STAFF RECOMMENDATION
3633 Richland Avenue
Lot 6, Richland Hall Development
May 17, 2017

Application: New construction—infill and outbuilding; setback determination
District: Richland-West End Neighborhood Conservation Zoning Overlay
Council District: 24
Map and Parcel Number: TBD
Applicant: Chad Gore, Mike Ford Builders
Project Lead: Melissa Baldock, melissa.baldock@nashville.gov

SITE PLAN

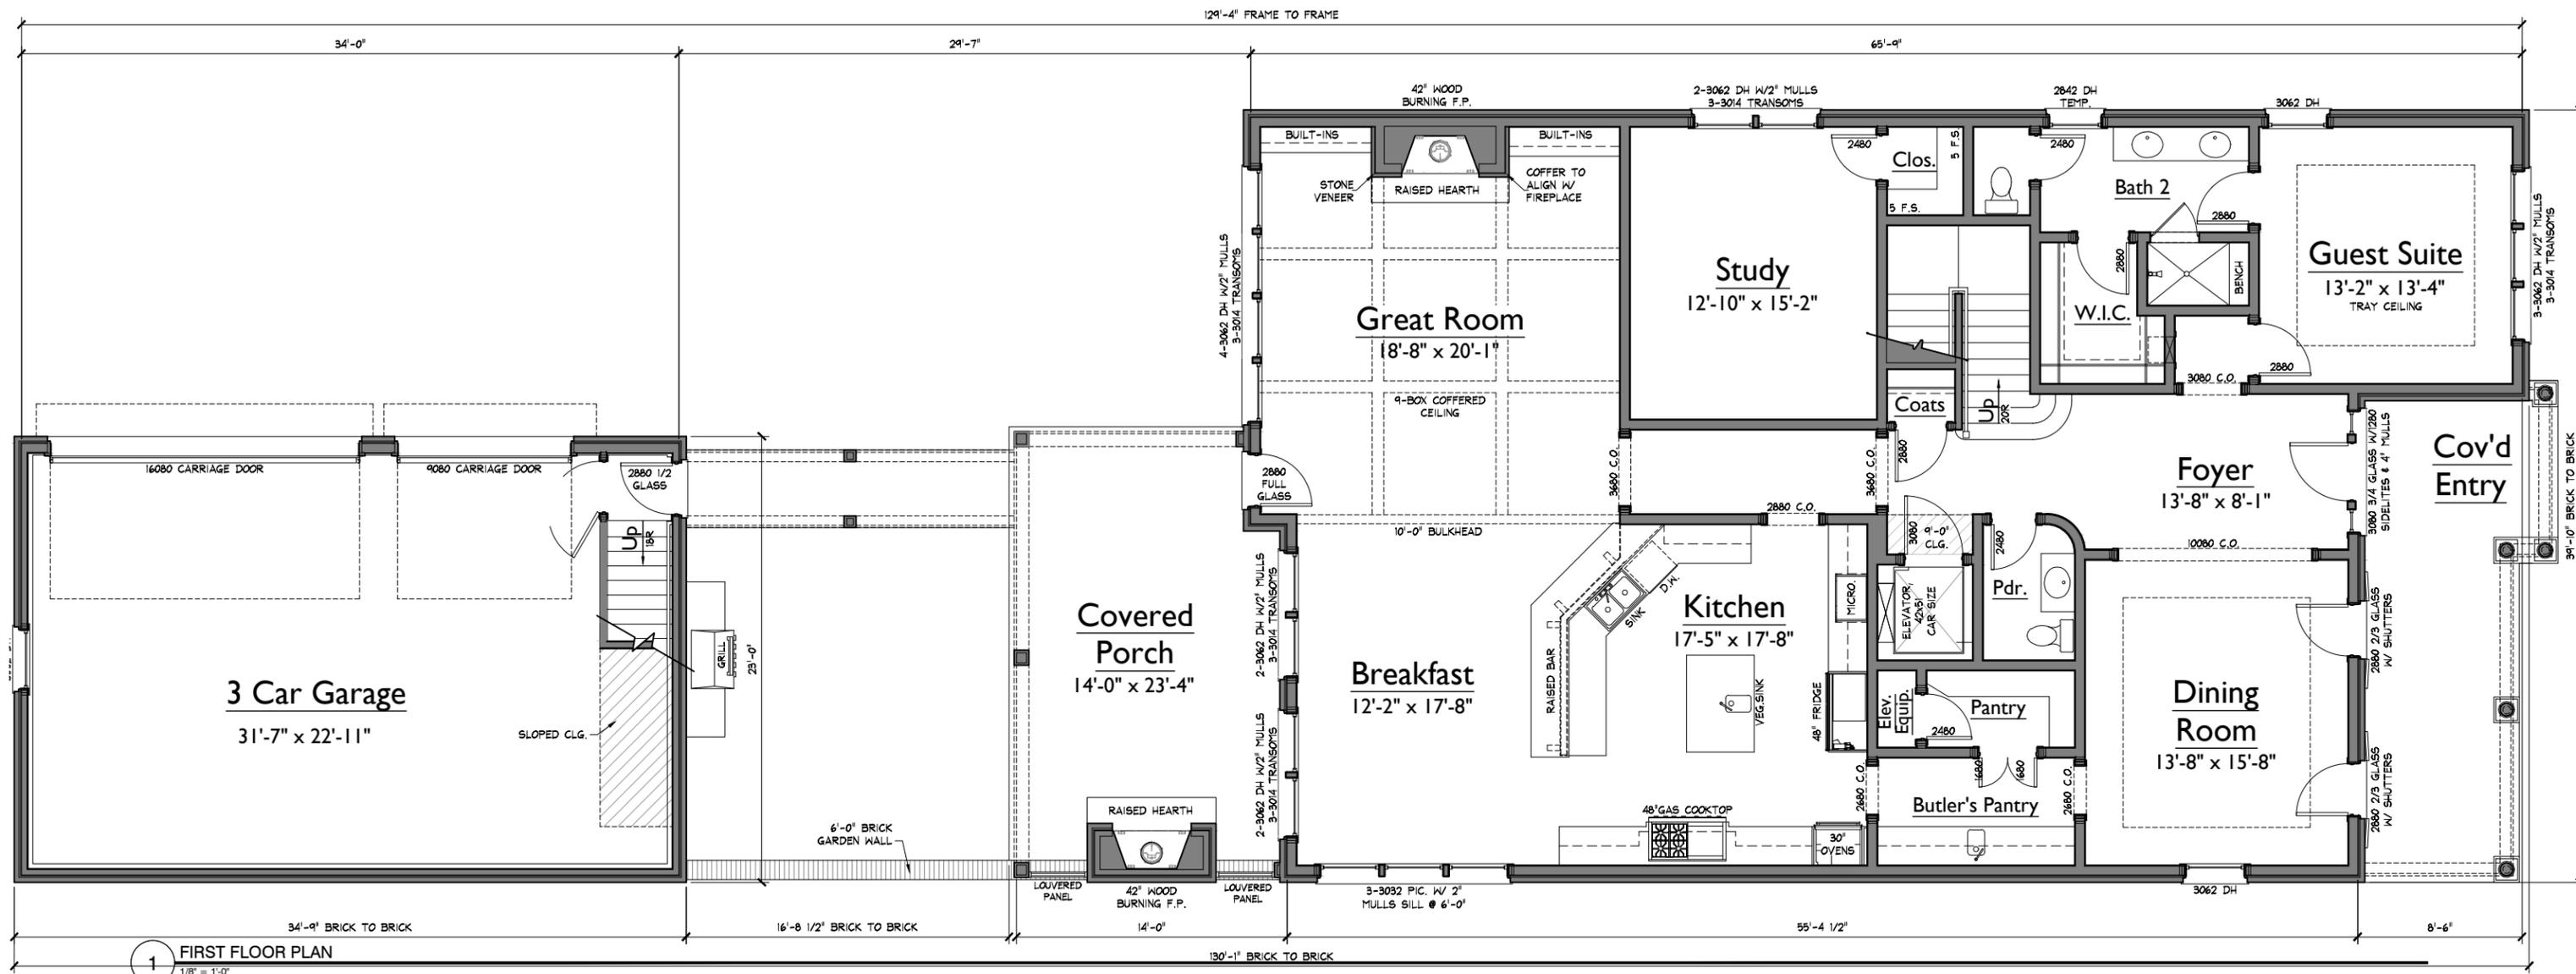
The right side elevation will be seven feet (7'1") from the side property line, which meets the base zoning setback of five feet (5'). On the left side, base zoning requires a five foot (5') side setback, but the applicant is proposing to set the infill just three feet (3'1") from the side property line. Staff finds this reduced side setback to be appropriate because there are other homes in the immediate vicinity that do not meet the required five foot (5') side setback. In addition, the infill is part of a larger development, and the reduced setback will affect the parcel next door at 3629 Richland Avenue, which is also part of the larger development. Staff has yet to review the site plan for 3629 Richland Avenue, but has directed the applicant that the right side of No. 3629 needs to be set more than seven feet (7') from the side property line. This will ensure there is at least ten feet (10') in between nos. 3633 and 3629 Richland Avenue and that the reduced side setback will not affect overall rhythm of spacing on the street. For Lots 1, 2, 3, 4, And 5 of this development, the Commission has approved similar setback determinations.

*The Commission typically requests to see at least twenty feet (20') between the primary structure and the outbuilding. The applicant is proposing just sixteen feet, eight inches (16'8") in between the structures. The Commission has approved a shorter distance of ten feet (10') in between the primary structures and the outbuildings for Lots 1, 2, 3, 4, and 5 of this development. Staff recommends approval of the distance between the infill and the outbuilding for Lot 6. The overall development is creating a new alley at the rear of the lots, which will make the back portion of the lot unavailable for building. Approximately the back thirty feet (30') of the lot is used for the alley. In addition, there is a utility easement in between the alley and the outbuilding. The outbuilding cannot be pushed any further to the rear because of the new alley and the easements on the property. Therefore, staff finds that the distance in between the primary house and the outbuilding to be sufficient.

**Base zoning requires that outbuildings larger than seven hundred square feet (700 sq. ft.) be located twenty feet (20') from the rear property line and five feet (5') from the side property lines. The outbuilding will be more than twenty feet (20') from the rear property line, although it will appear to be much closer because the rear portion of the lot will be dedicated to a new private alley. The outbuilding will meet the right side setback, but will require a side setback determination left side property line. It will be just three feet (3') from the left side property line rather than the required five feet (5'). Staff finds the proposed three foot (3') side setback to be appropriate because it will line up with the setback of the proposed infill. In addition, historically, outbuildings were located close to or on the side property lines. MHZC approved three foot (3') left side setbacks for Lots 1, 2, 3, 4, and 5 of this development.

RICHLAND HALL LOT 006
ELEVATIONS

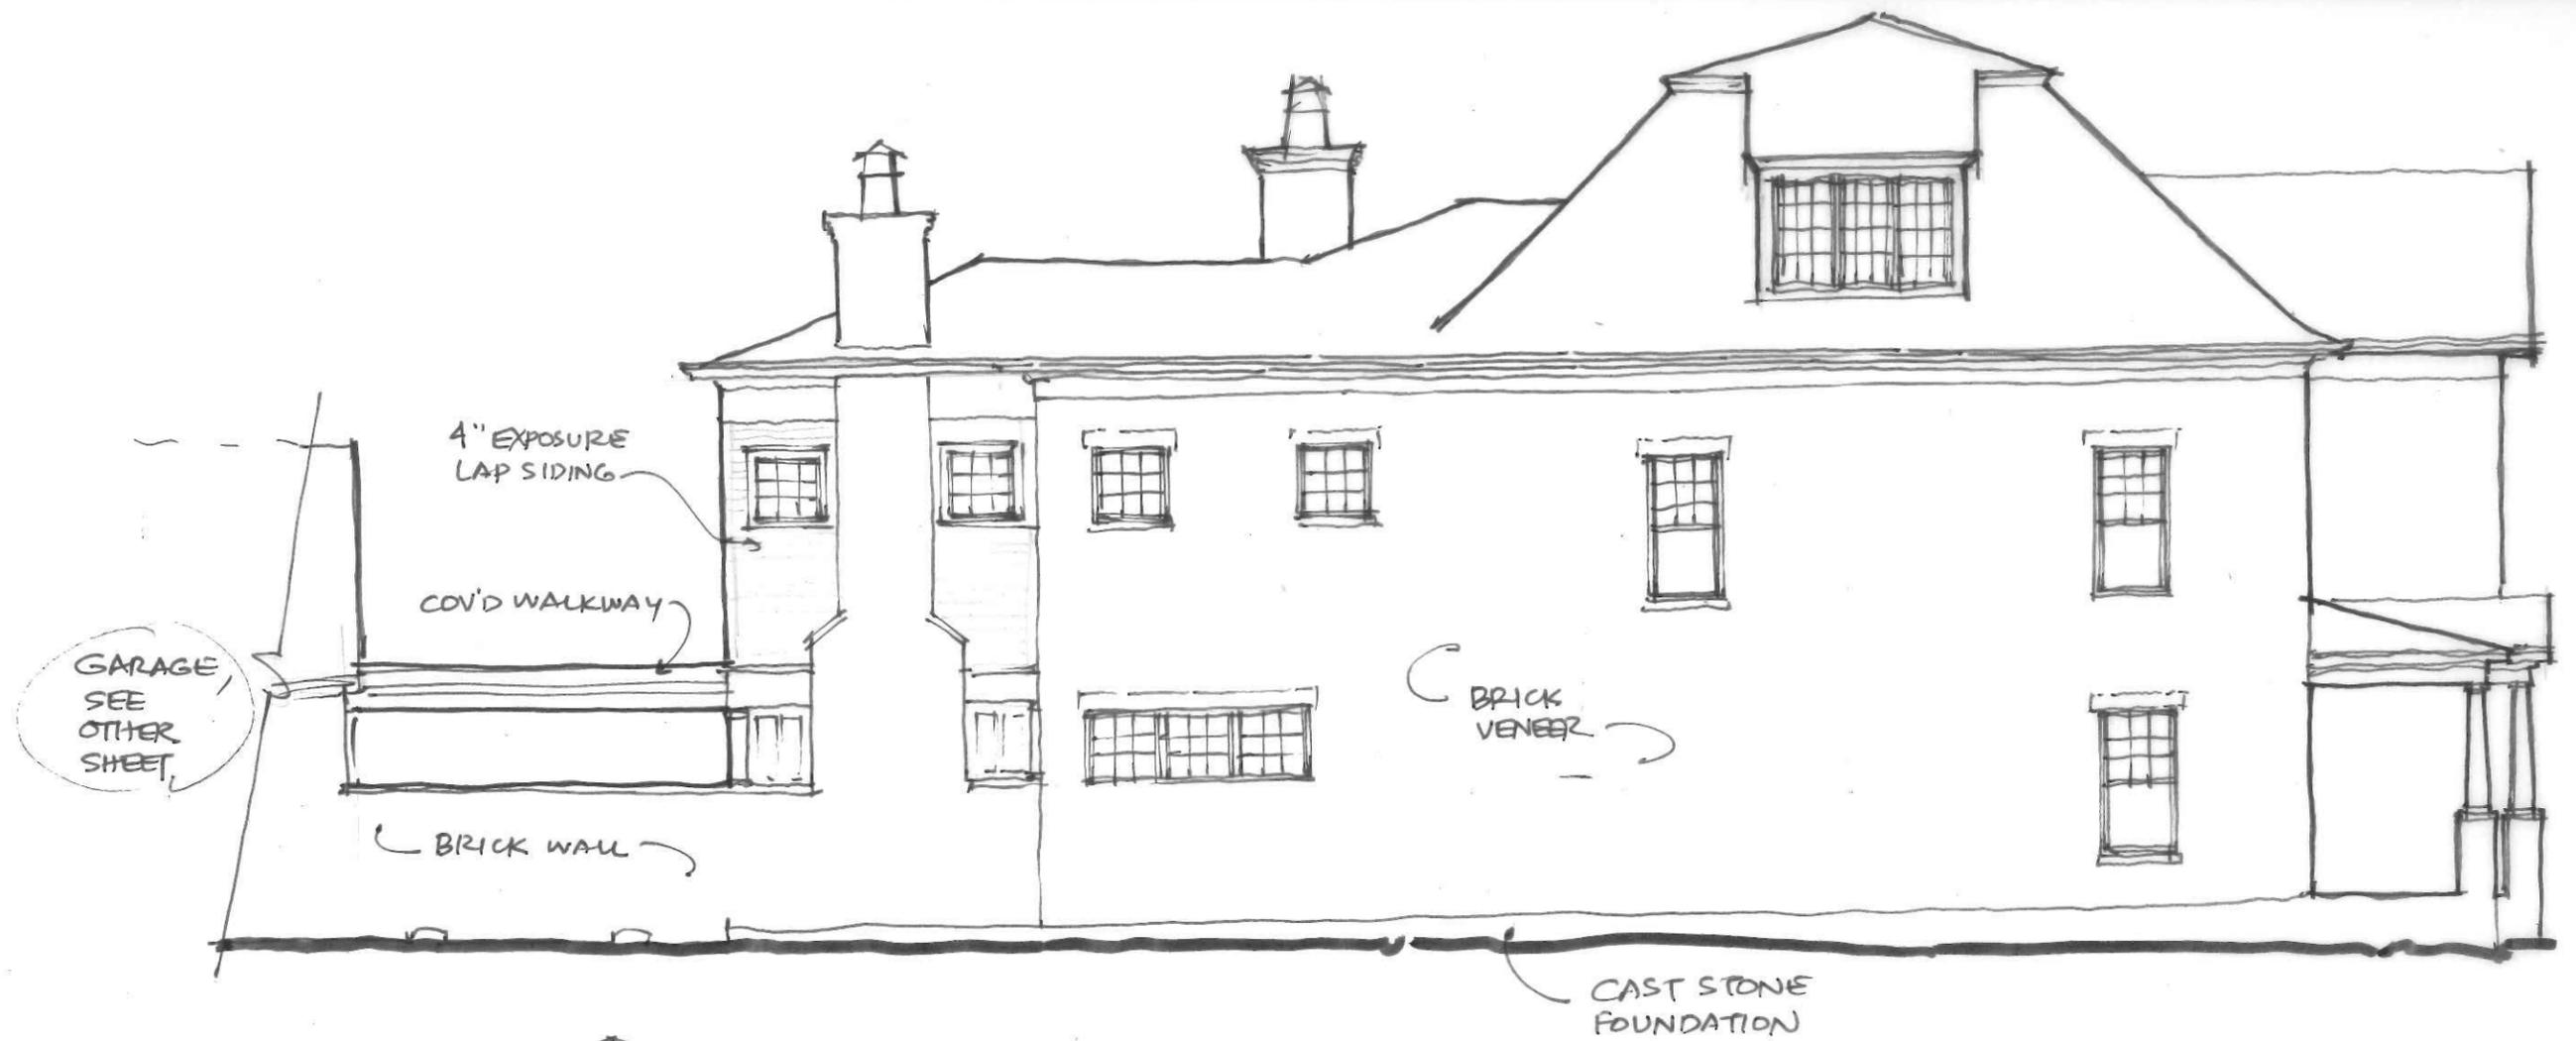
Height & Scale: The proposed infill will be two stories, with a maximum height of thirty-five feet (36') above the foundation at the front, and approximately thirty-eight feet (38') above grade. About twenty feet (20') back from the front wall, the house will increase in size by approximately two feet, six inches (2'6") to have a maximum height of thirty-eight feet, six inches (38'6") above the foundation. The infill will have an eave height of twenty-four feet (24') above the foundation. The foundation height will vary due to grade, but will be between two feet and two feet, six inches (2'-2'6") at the front. Staff finds that the proposed height is similar to the heights of historic houses in the

Roof form: The infill's primary roof form is a hipped roof with a 10/12 pitch. A projecting bay on the front will have a gable roof form with a 10/12 pitch. The taller bump out on the roof will be hipped with a 4/12 pitch, and the rear portion of the house will have 6/12 hipped forms. Staff finds that the proposed roof forms are appropriate for a two-story infill house in the overlay, and finds that the roof forms meet Section II.B.1.e. of the design guidelines.

openings. There is an expanse of over thirty feet (30') without a window or door opening on the left façade. Staff recommends that a window opening that is vertically oriented and at least four square feet (4 sq. ft.) in area be added to this façade. In addition, staff recommends that all double and triple window openings have a four to six inch (4"-6") mullion in between them. With these conditions, staff finds that the infill's proportion and rhythm of openings meet Section II.B.1.g. of the design guidelines.

GARAGE ELEVATIONS

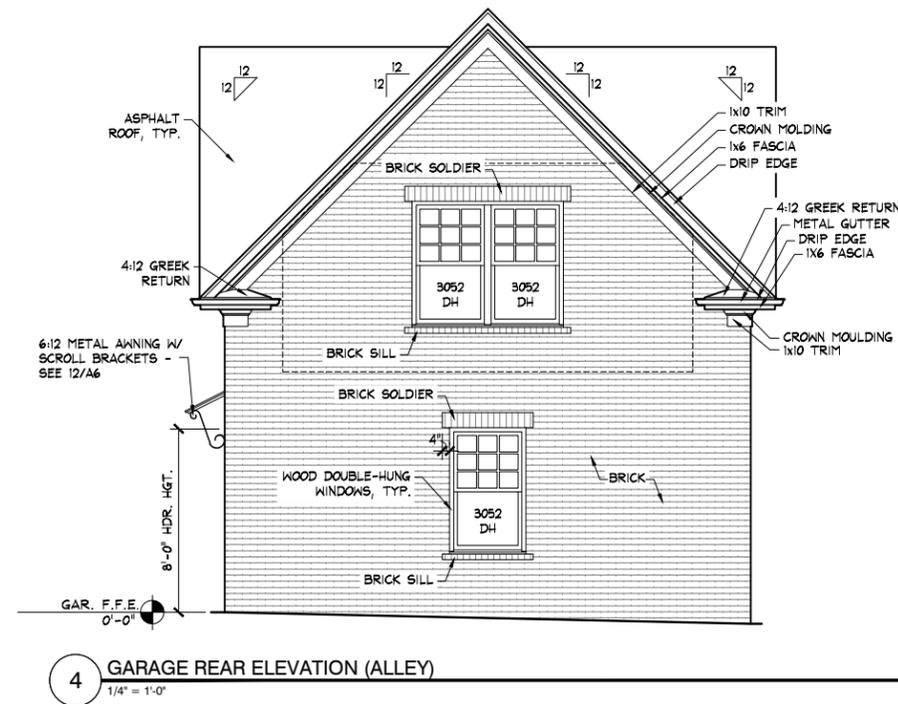
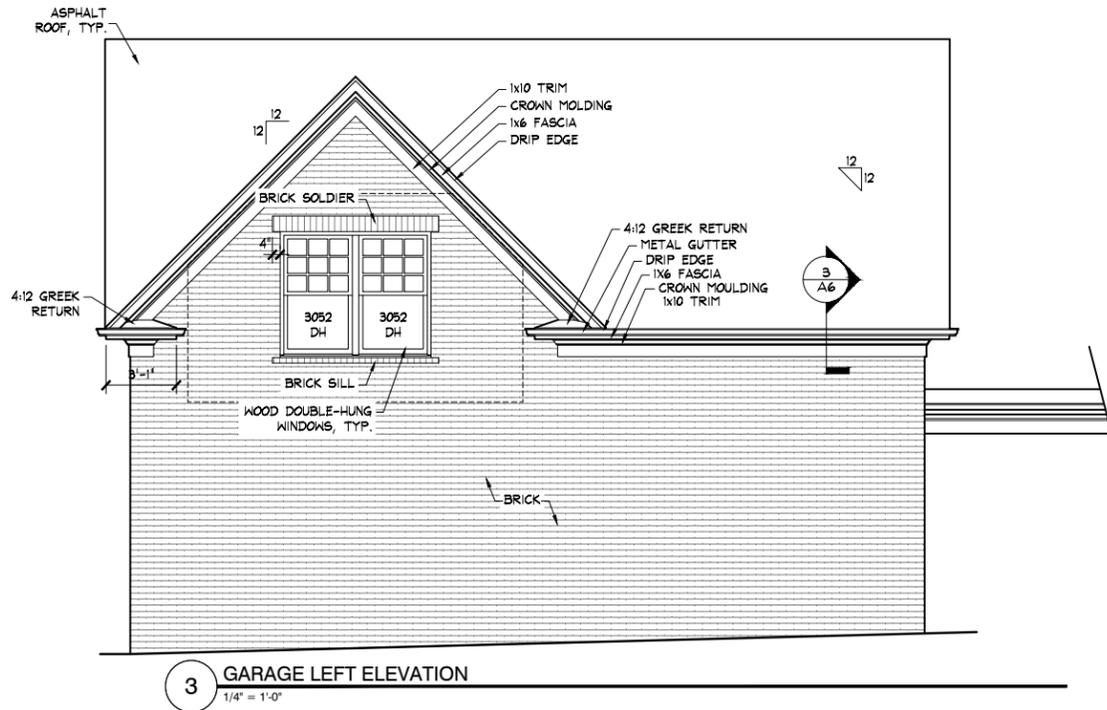
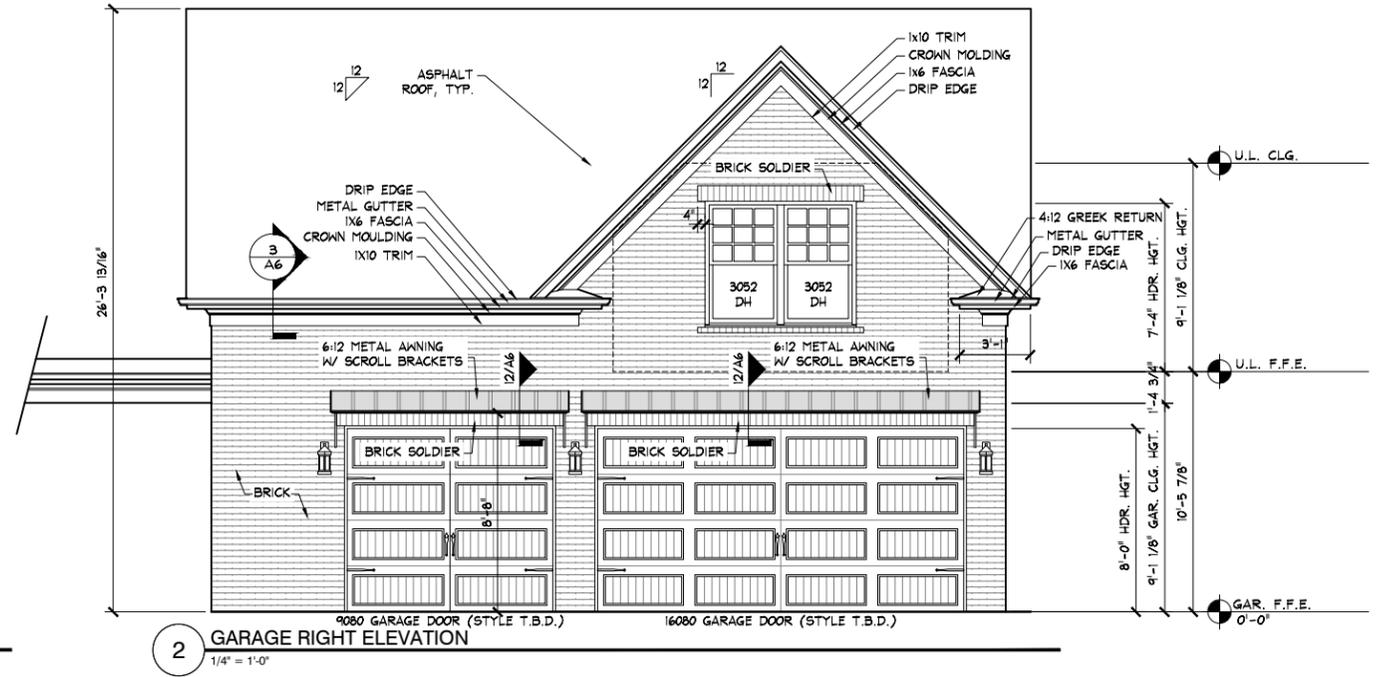
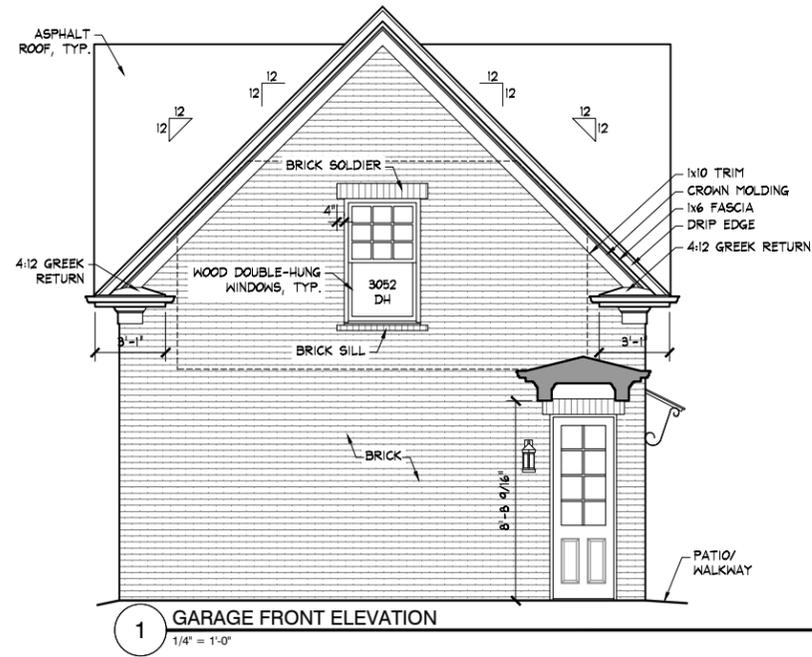
***The drawings show the outbuilding as being twenty-six feet, four inches (26'4") tall, but the design guidelines limit outbuildings to twenty-five feet (25') tall. Staff recommends that the outbuilding height be reduced so that it is no taller than twenty-five feet (25').

With the final approval of all materials and the lowering of the height to a maximum of twenty-five feet (25'), staff finds that the proposed outbuilding meets Section II.B.1.h of the design guidelines.
